City of Portland, Oregon
Bureau of Development Services
Land Use Services

NOTICE OF A TYPE IX DECISION ON A PROPOSAL IN YOUR NEIGHBORHOOD

CASE FILE NUMBER: LU 16-134009 LDP

Land Division Partition (LDP)

CASE NO. 16-134009
EXHIBIT C.1

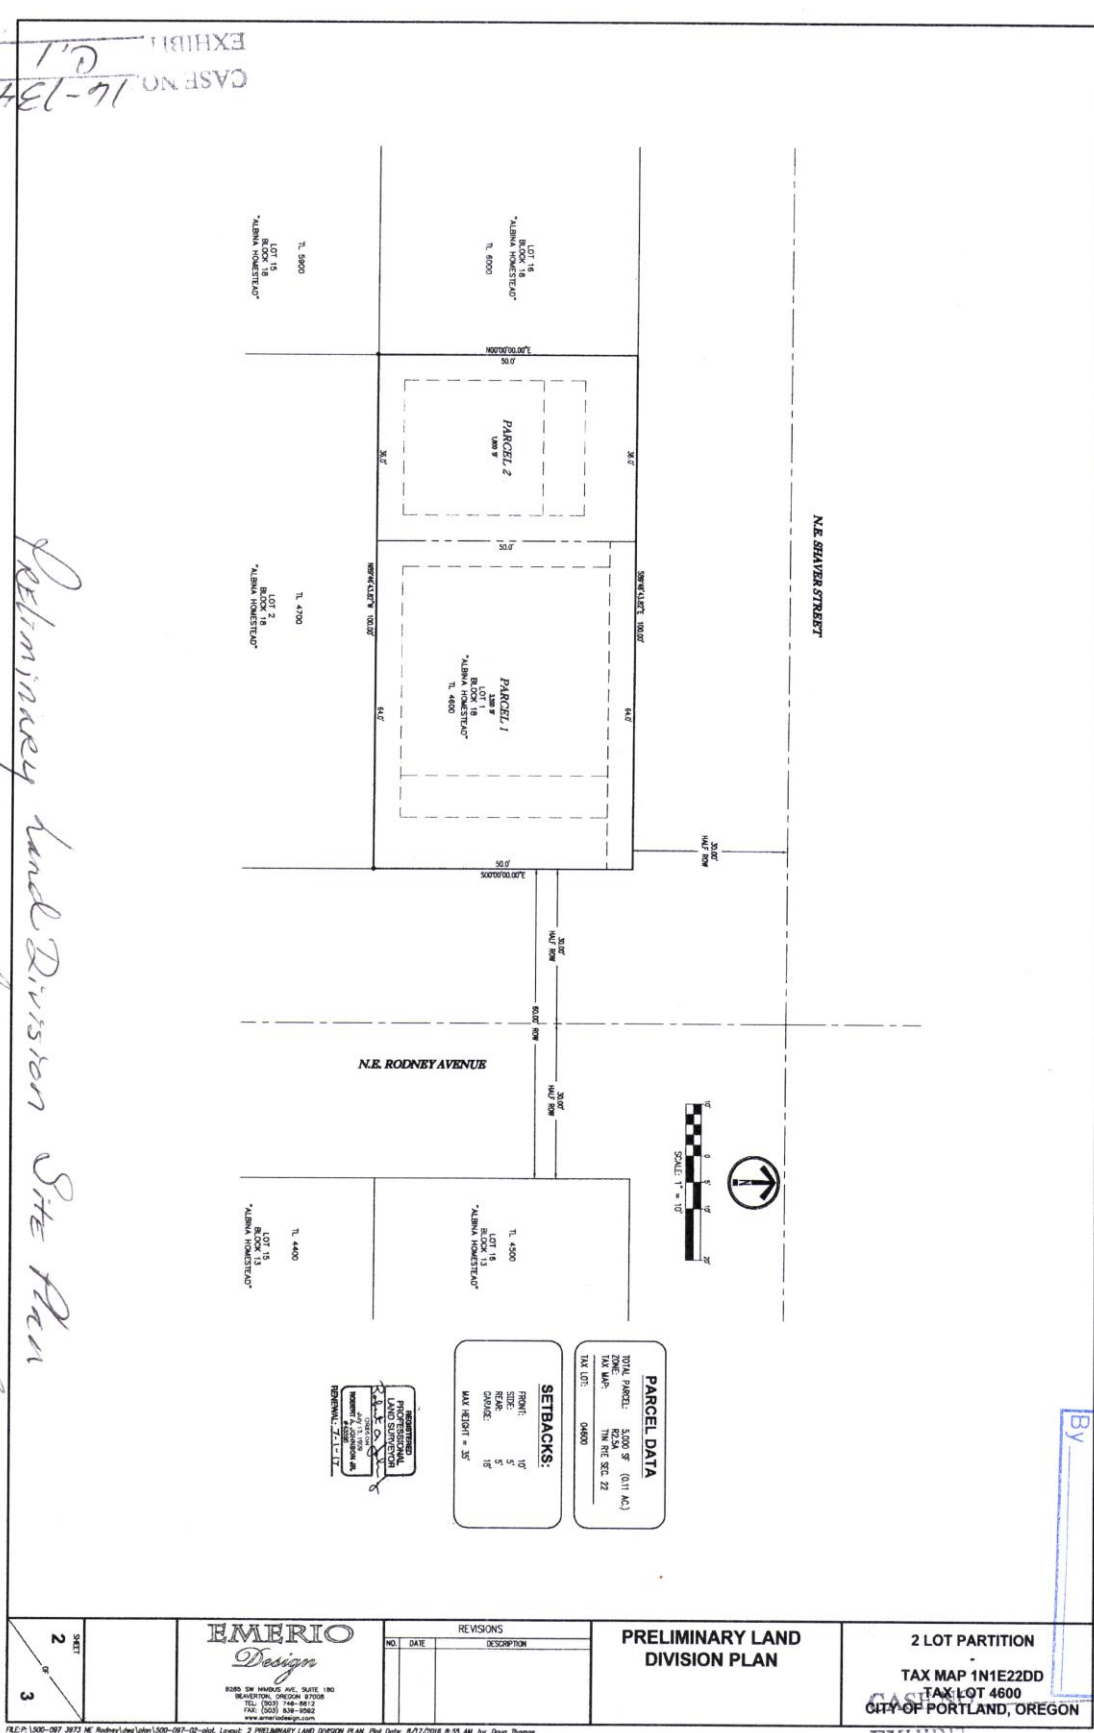
The applicant has proposed a two lot partition, as shown on the attached preliminary plan (Exhibit C.1). As discussed in this report, the relevant standards and approval criteria have been met, or can be met with conditions. The primary issues with this proposal include; locating how the existing house disposed of stormwater, access to public sanitary in NE Rodney Avenue for Parcel 2, existing condition of driveway within right-of-way along NE Rodney's frontage, Title 11 requirements for street trees and meeting Title 33 development standards for the existing house on its new lot.

Approval of a Preliminary Plan for a two-parcel partition, that will result in two standard single dwelling lots as illustrated with Exhibit C.1, subject to the following conditions:
